# STATE OF NEW HAMPSHIRE INTER-DEPARTMENT COMMUNICATION

**SUBJECT** Permit Amendment  
Auburn, 44167

# AMENDED WETLAND PERMIT PLANS FEDERAL AID PROJECT

NH ROUTE 121  
CULVERT REPLACEMENT  
WETLAND IMPACT AND  
EROSION CONTROL PLANS

STATE OF NEW HAMPSHIRE AUBURN			
DEPARTMENT OF TRANSPORTATION		BUREAU OF HIGHWAY DESIGN	
<b>WETLAND IMPACT PLAN</b>			
DGN	STATE PROJECT NO.	SHEET NO.	TOTAL SHEETS
04 44167-wetplan	44167	4	9

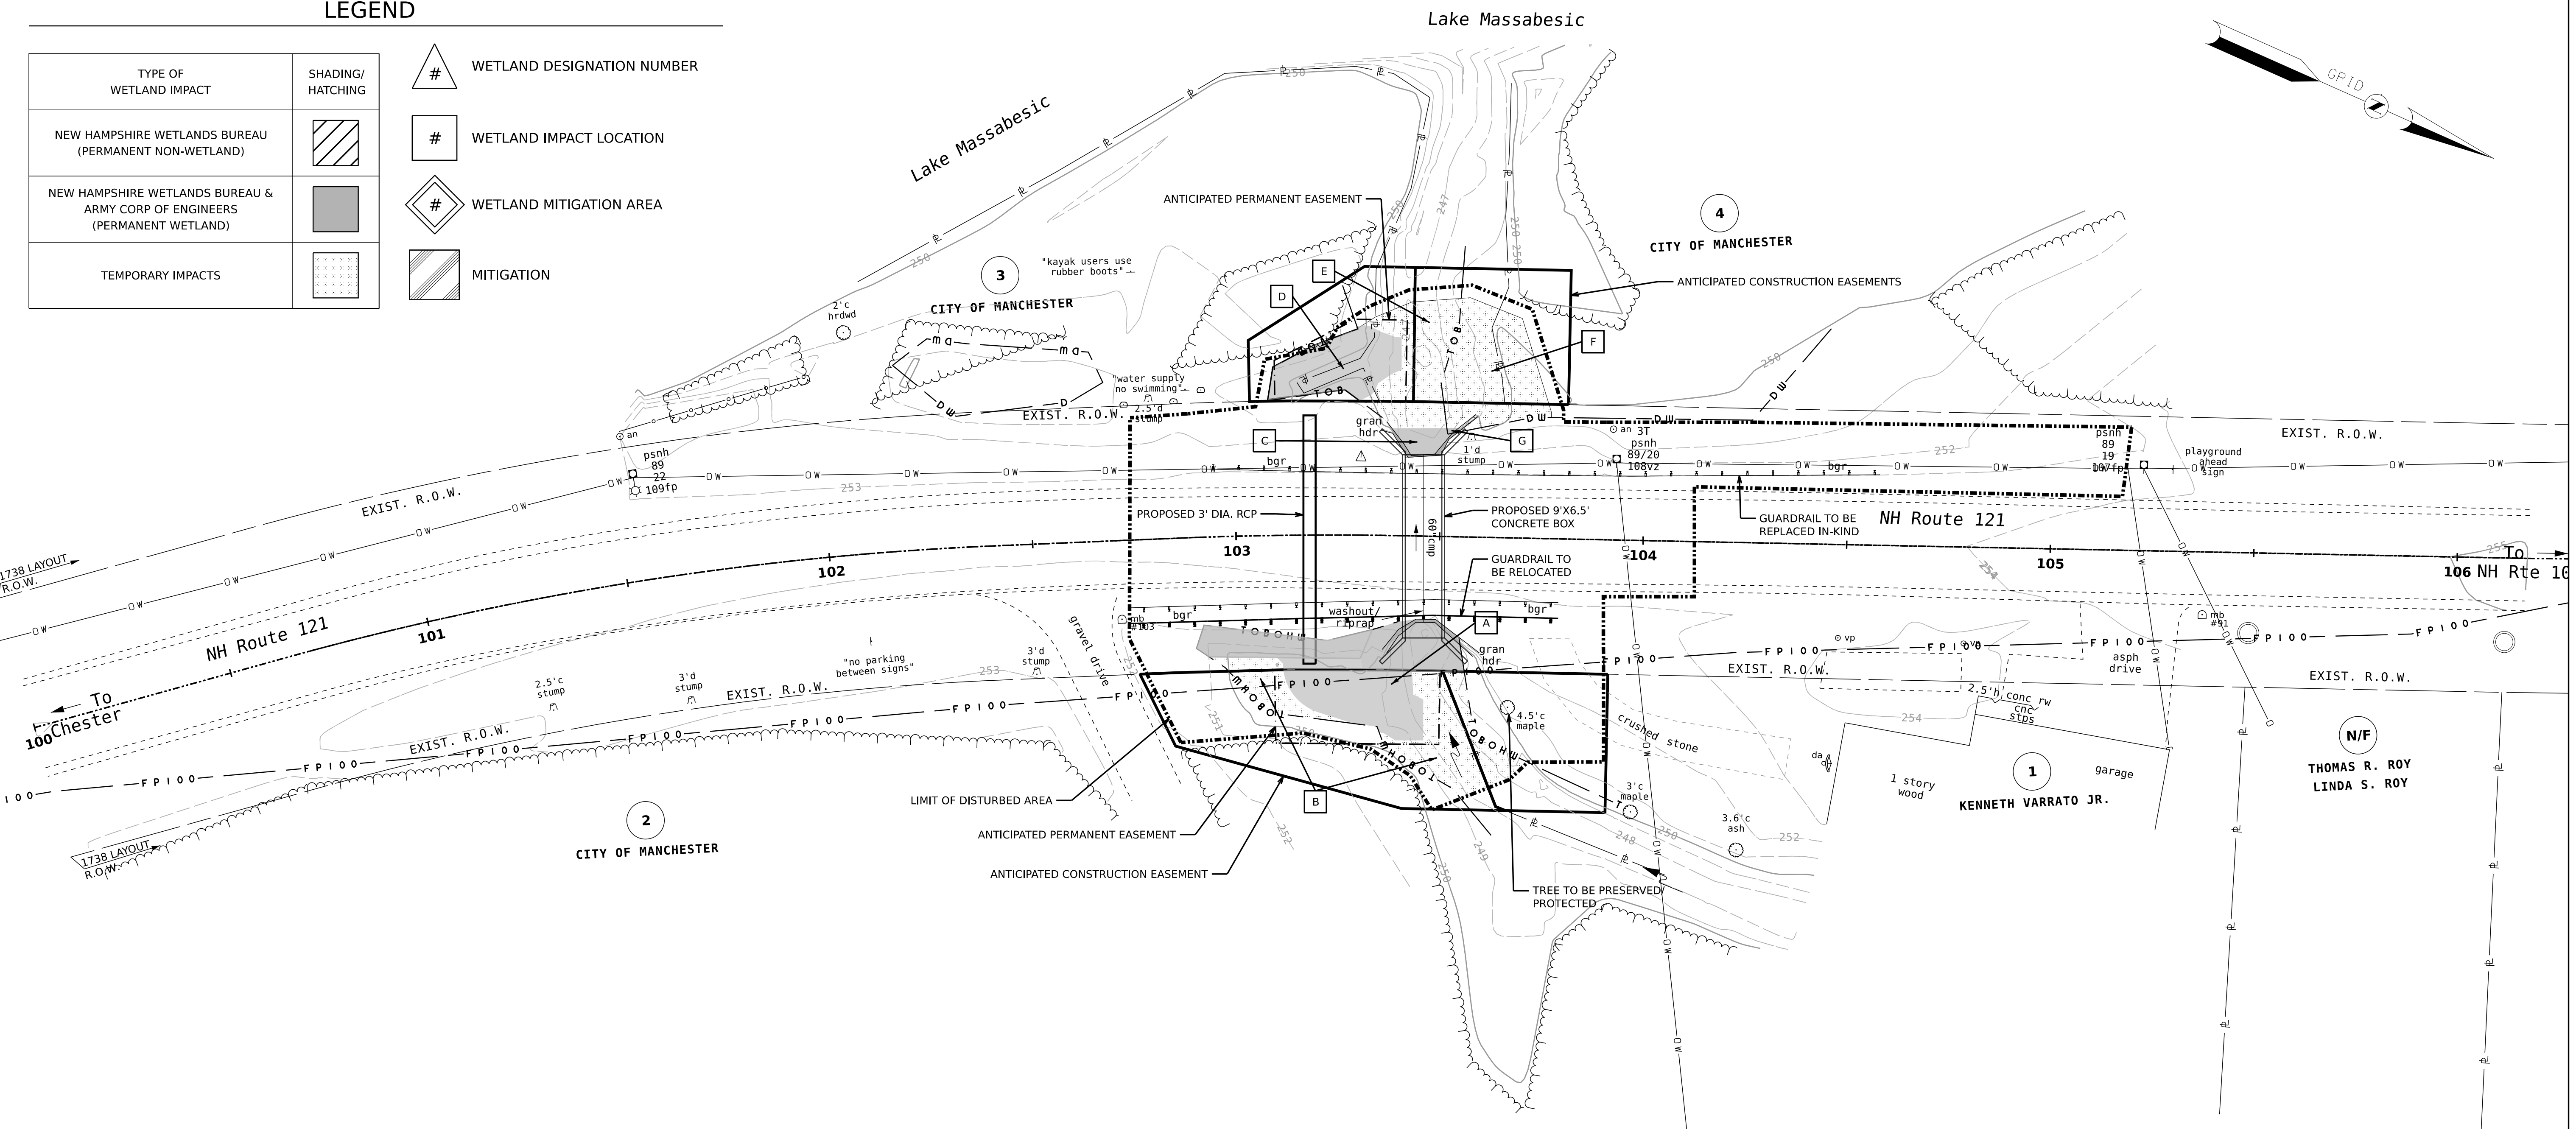
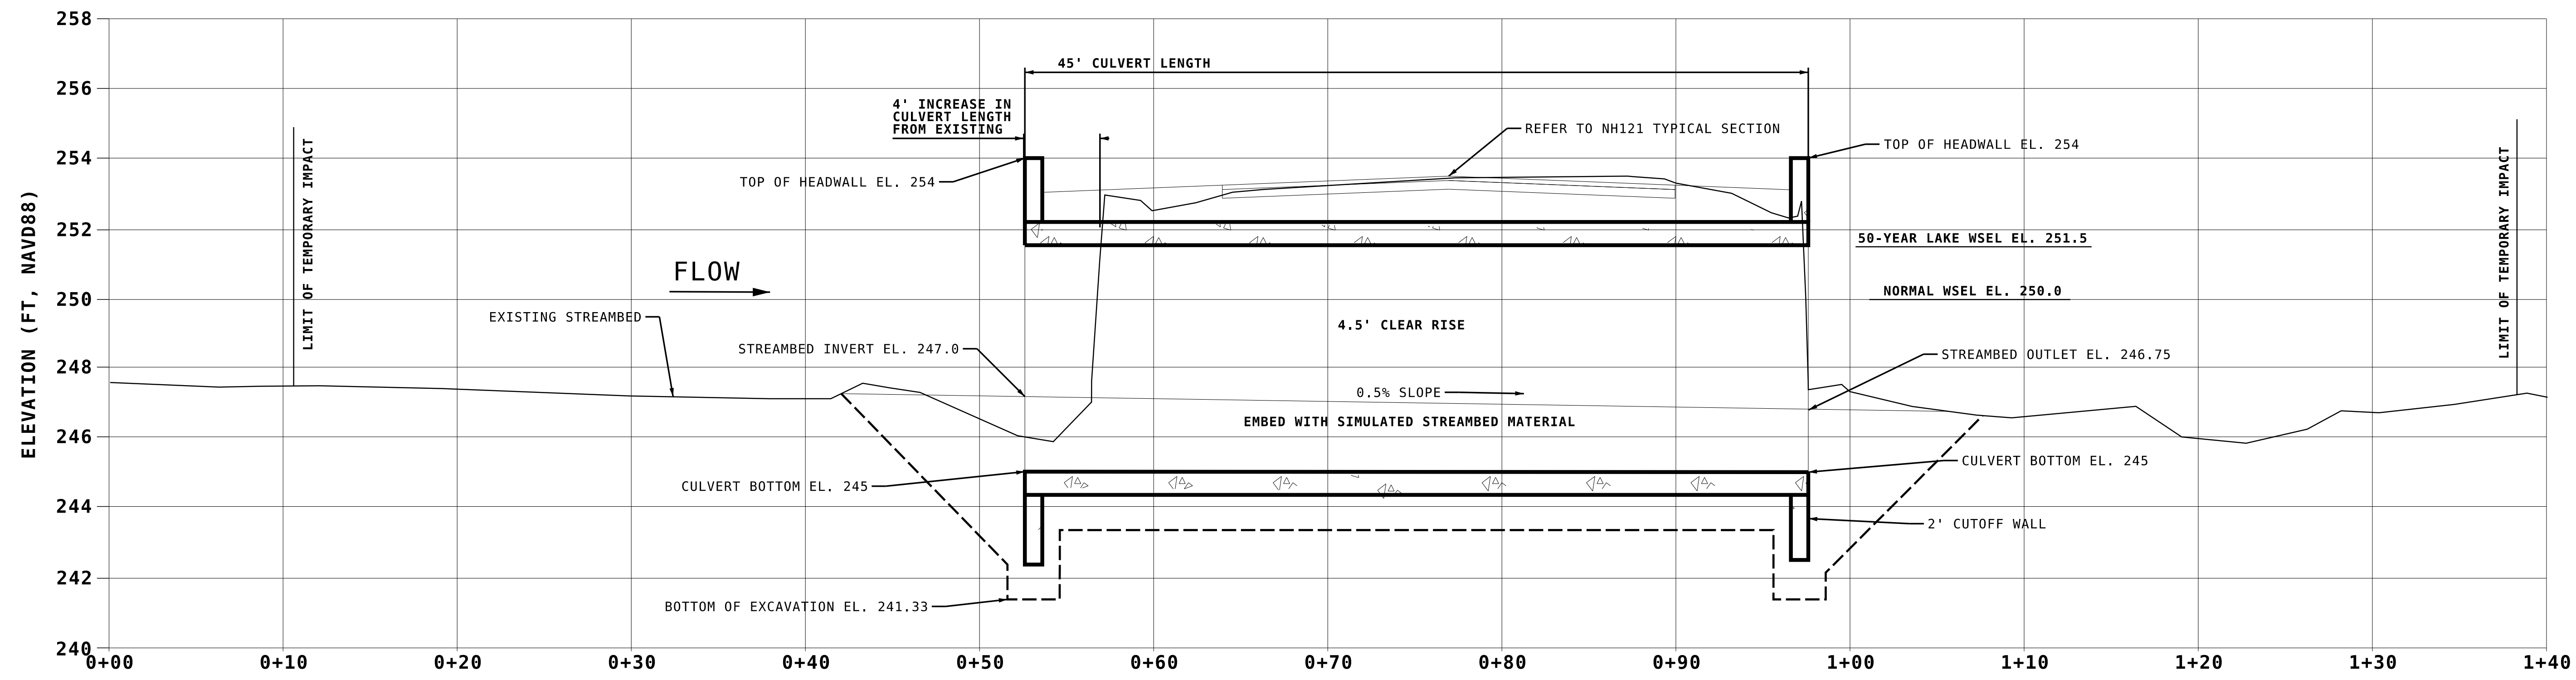
STA 103+46:  
 REPLACE EXISTING 60" DIA. 41' LONG CMP CULVERT WITH 9' SPAN X 5' RISE (4' CLEAR HEIGHT) X 45' LONG PRECAST CONCRETE BOX CULVERT EMBEDDED 1' BELOW STREAMBED. CONSTRUCT CONCRETE HEADWALLS AT BOTH ENDS ANGLED AT 45 DEGREES TOWARDS THE BANK.

STATE OF NEW HAMPSHIRE AUBURN			
DEPARTMENT OF TRANSPORTATION		BUREAU OF HIGHWAY DESIGN	
<b>RCP PLAN, PROFILE, AND CHANNEL DETAIL</b>			
DGN	STATE PROJECT NO.	SHEET NO.	TOTAL SHEETS
07 44167-RCP	44167	6	8

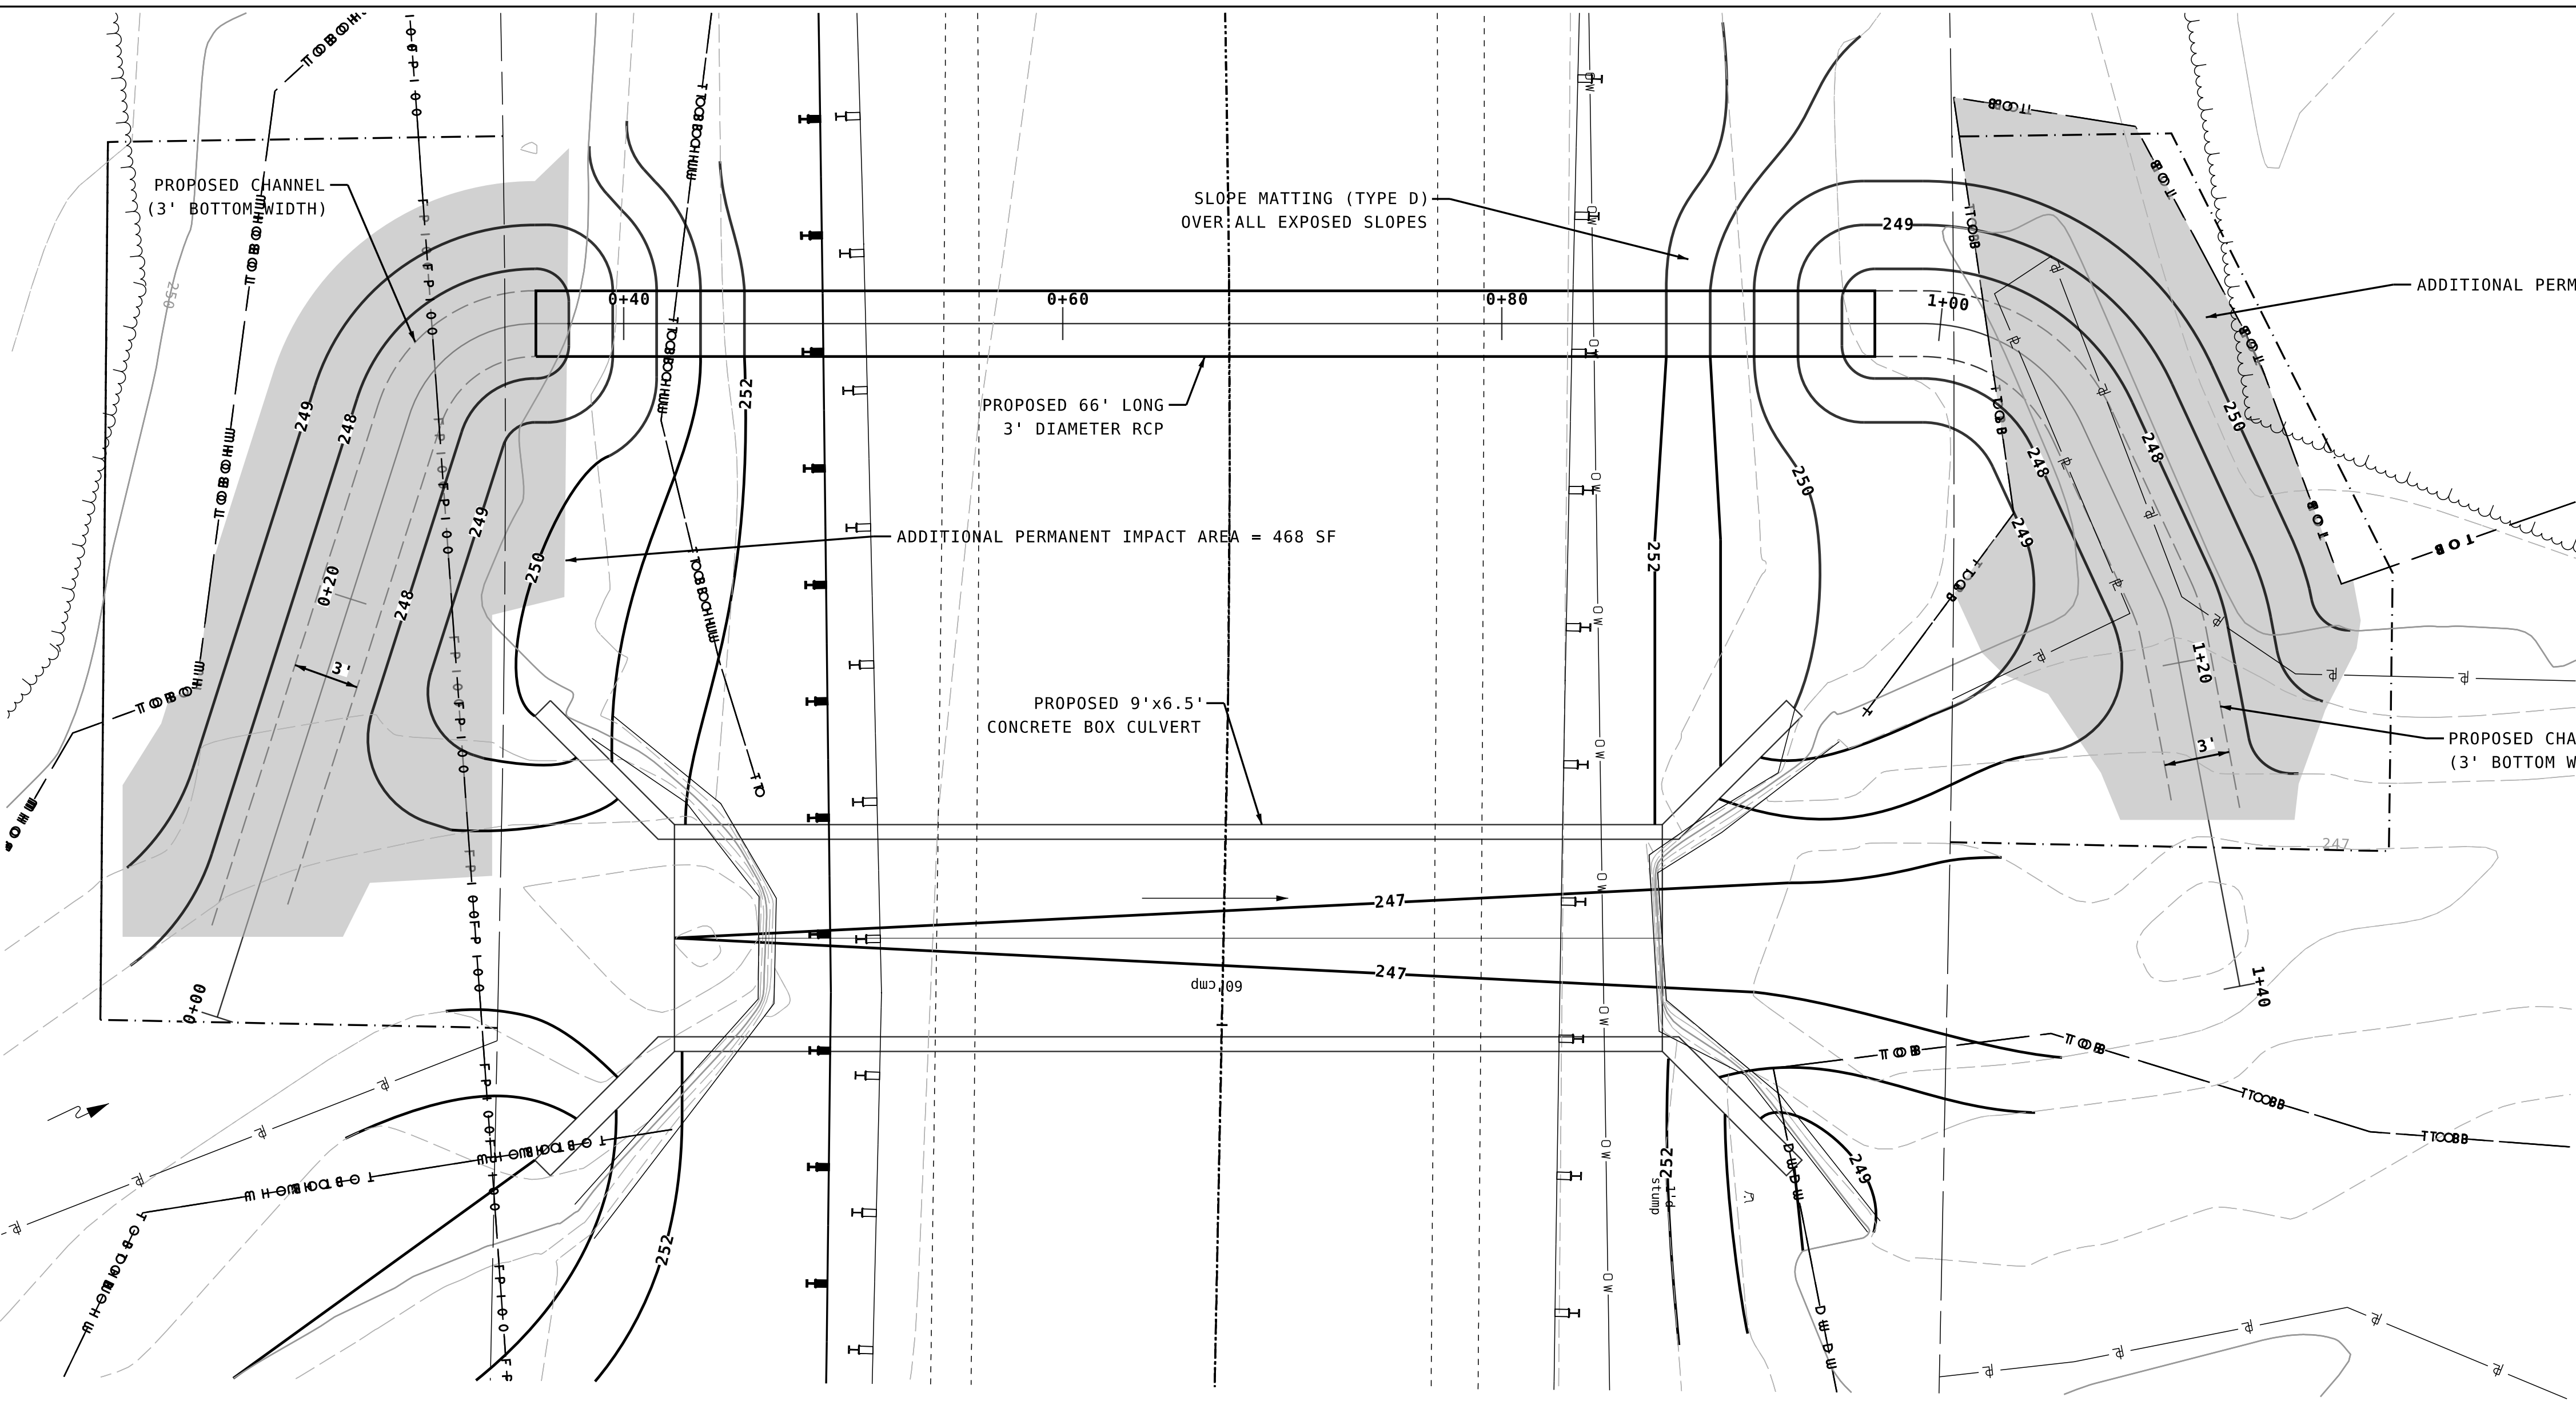
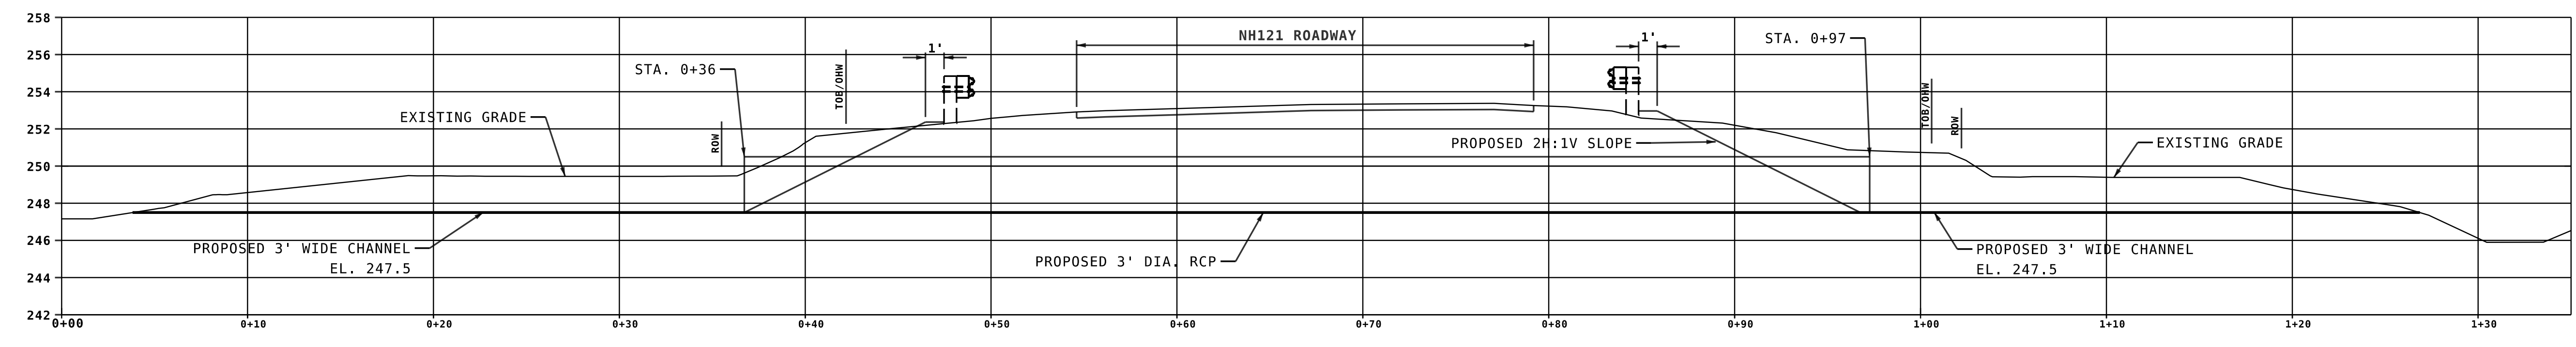
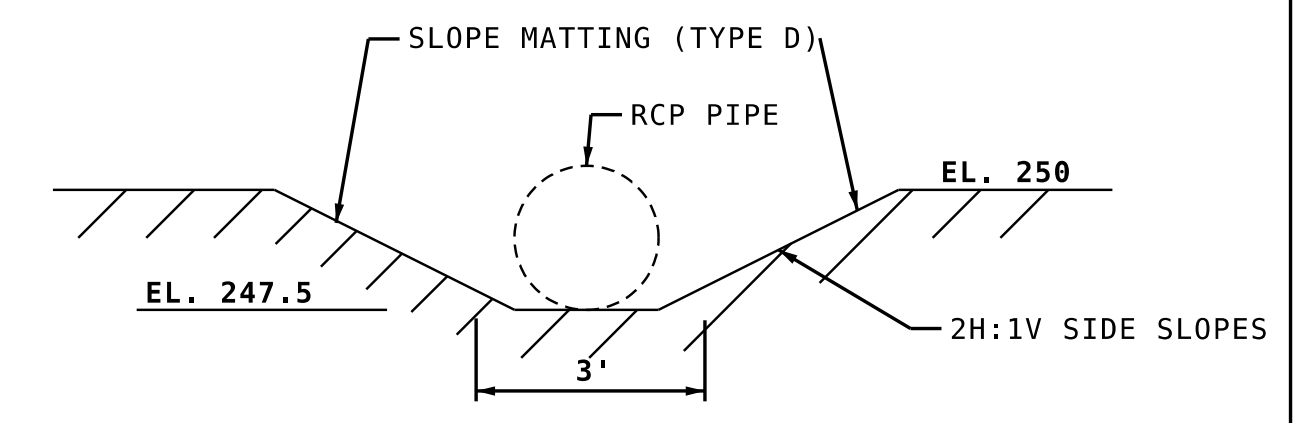
In December 2023, after being notified of the potential future increase to Massabesic Lake, Alternative 3 (the selected alternative) was revised to increase the height from 6' to 6.5' (4.5' open rise) and the previously temporary bypass pipe is now proposed as a permanent 3' diameter reinforced concrete pipe. Construction considerations are the same. The proposed culverts are calculated to accommodate a 1 foot increase in tailwater (up to EL. 252.5) before overtopping at the 50-year event.

NOTE: THIS SHEET ONLY SHOWS THE ADDITIONAL PERMANENT WETLAND IMPACTS, WHICH HAVE PREVIOUSLY BEEN PERMITTED AS TEMPORARY IMPACTS.
